COUNTY OF SANTA CRUZ

September 30, 2011

Subject: Application 06-0389, APN: 037-221-35

Proposal to divide a 40,337 square foot parcel into four residential lots for the construction of one single-family dwelling on each lot. Requires a Minor Land Division, Residential Development Permit to construct four new dwellings and related improvements, Roadway/Roadside Exception, an exception for access from a right-of-way of less than 40 feet in width, and a Preliminary Grading Approval to grade 989 cubic yards. Property located at the northwest end of the Abbey Road cul-de-sac, approximately 300 feet northwest of Willowbrook Drive (6125 Abbey Road).

AXONOMETRIC VIEW

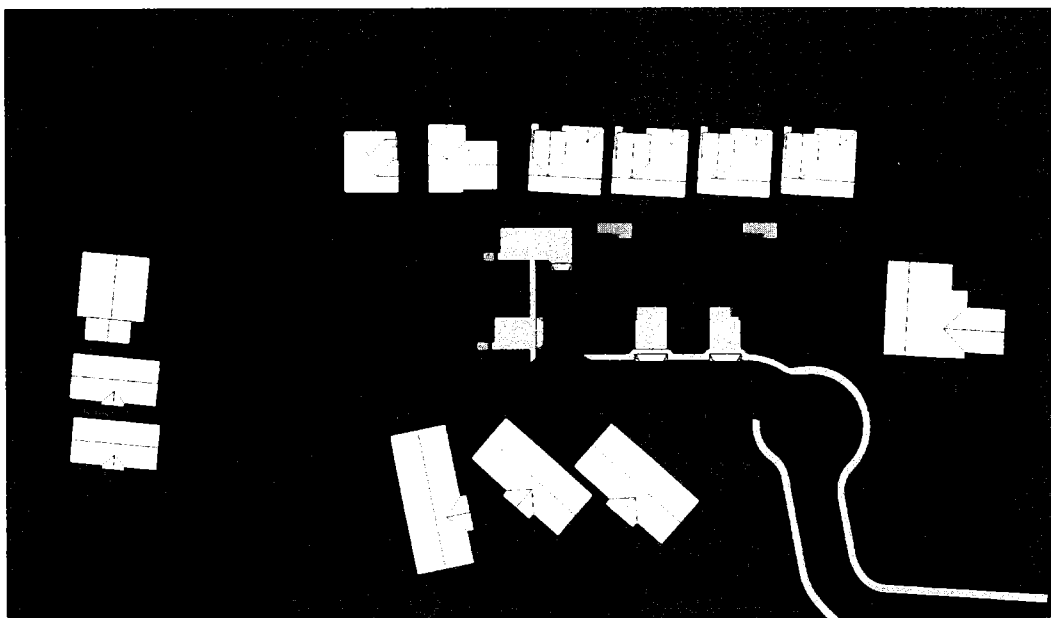
An axonometric and shadow plan were not provided with the original project plans. Axonometric plans are required for urban land divisions to show how the proposed development fits into the existing neighborhood. Shadow plans show the potential changes in solar access to neighboring properties. William Kempf, project architect, submitted axonometric and shadow plans (see Exhibit A).

The submitted axonometric plan demonstrates that this in-fill development will be compatible with the existing neighborhood where there is a mixture of one and two-story dwellings. As expected, the shadow plan shows that the most significant impact to solar access will be to the dwellings to the north which are located on Jason Court. During summer, there will be minimal shading impacts to adjacent properties. During winter, however, the proposed dwellings will shade six of the Jason Court townhomes. Neighbors at the first hearing expressed concern about shading. Some shading, however, is unavoidable with in-fill development at urban densities. The proposed development meets the zone district's required setbacks and the dwellings are below the 28 foot height limit.

A3.3

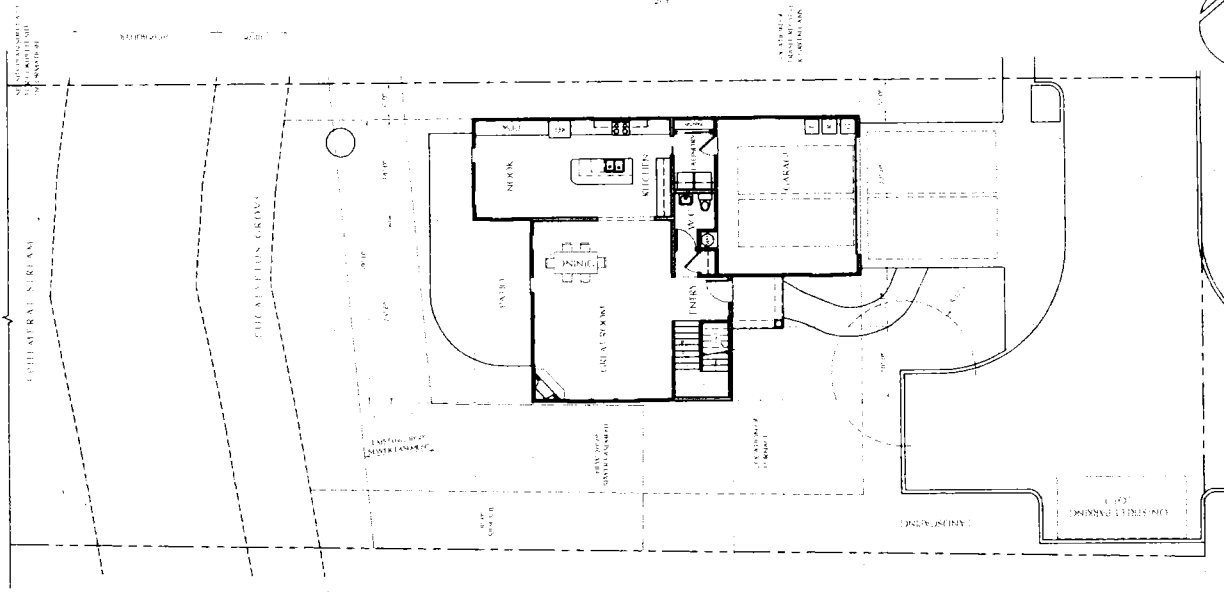
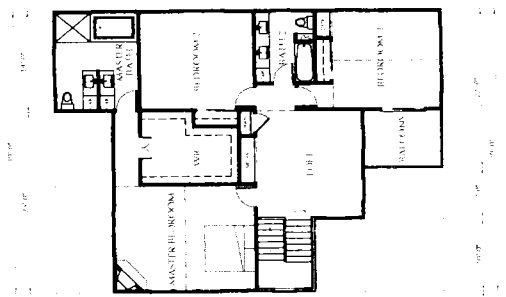
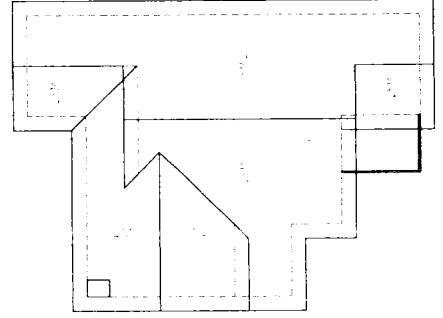
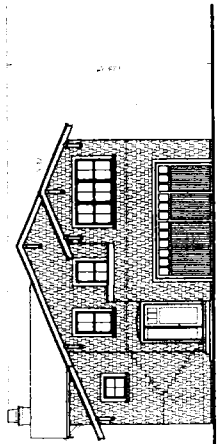
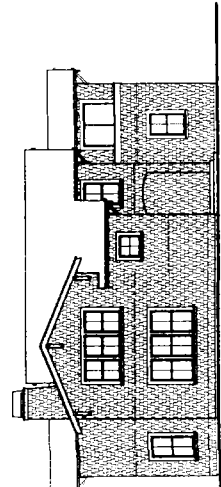
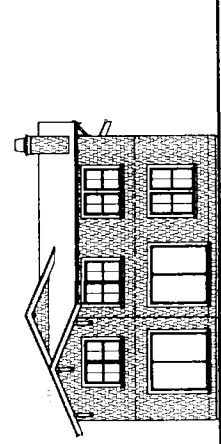
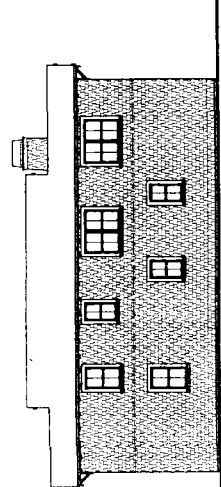
The revised architectural plans for the dwelling on Lot 3 are included in Exhibit A (sheet A3.3). The mass and bulk of the dwelling on Lot 3 are essentially the same.

The most significant architectural changes are: the chimney was moved to the western side of the structure, and larger windows are located on the first and second floors. The revised structure on Lot 3 continues to comply with the zone district site standards.
